Rules and Regulations for the Classification of Naval Ships, January 2013

Notice No. 5

Issue date: November 2013

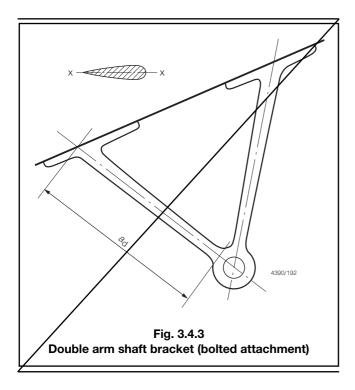
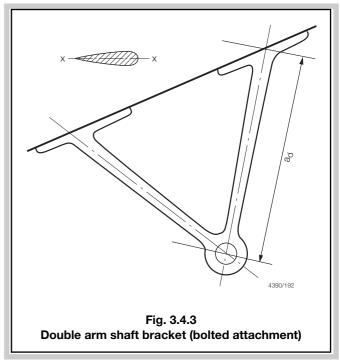
#### 4.7 Double arm shaft brackets ('A' - brackets)

4.7.2 The arms of double arm shaft brackets are to have a section modulus,  $Z_{\rm xx}$ , of not less than that determined from the formula:

n = the minimum thickness, in cm, of a hydrofoil section obtained from:

$$n = d_{\text{ms}} \sqrt{\left(\frac{f}{2000}\right)\left(1 + \sqrt{\left(1 + \left(\frac{0.0112}{f}\right)\left(\frac{a_{\text{d}}}{d_{\text{ms}}}\right)^2\right)}\right)} \quad \text{cm}$$

$$n = d_{\rm up} \sqrt{\left(\frac{f}{2000}\right) \left(1 + \sqrt{\left(1 + \left(\frac{0.0112}{f}\right) \left(\frac{a_{\rm d}}{d_{\rm up}}\right)^2\right)}\right)}$$
 cm

$a_{\rm d}$  = the length of the longer strut, in mm, see Fig. 3.4.3  $\theta_{\rm me}$   $d_{\rm up}$  and f are as given in 4.6.1.
